## FLHTCSE<sup>2</sup> TOUR-PAK INTERIOR LIGHT REPLACEMENT Product Program P14

### Purpose

Figure 1. Mechanical Switch Tour-Pak Interior Light  
(P/N 54302-98A )

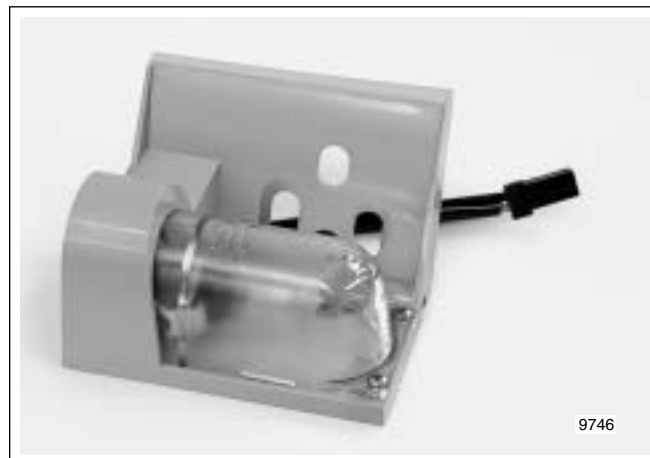
On certain 2005 FLHTCSE<sup>2</sup> model motorcycles, failure of the mechanical switch may cause the Tour-Pak interior light to stay on when the lid is closed, possibly resulting in battery drain.

In the interest of customer satisfaction, Harley-Davidson has elected to replace the old style mechanical switch (P/N 54302-98A) with the LED (P/N 54332-04) on all affected motorcycles. See REQUIRED DEALER ACTION to perform the replacement procedure.

Remove the mechanical switch type Tour-Pak interior light and install the LED. Exercise care to avoid replacing mercury switch type lights as they are not subject to this program. See IMPORTANT NOTE which follows. Replacement LED style lights that may already have been installed also are not included.

*It is difficult to visually distinguish the earlier style mercury switch light from the later style mechanical switch light. To determine switch type, first open the Tour-Pak to illuminate the interior light. Lightly tap the light, and if it flickers, it is the ball in the mechanical switch breaking contact- replace the light. If the light does not flicker, but remains steady, then it is the mercury switch type, and the light should **NOT** be replaced.*
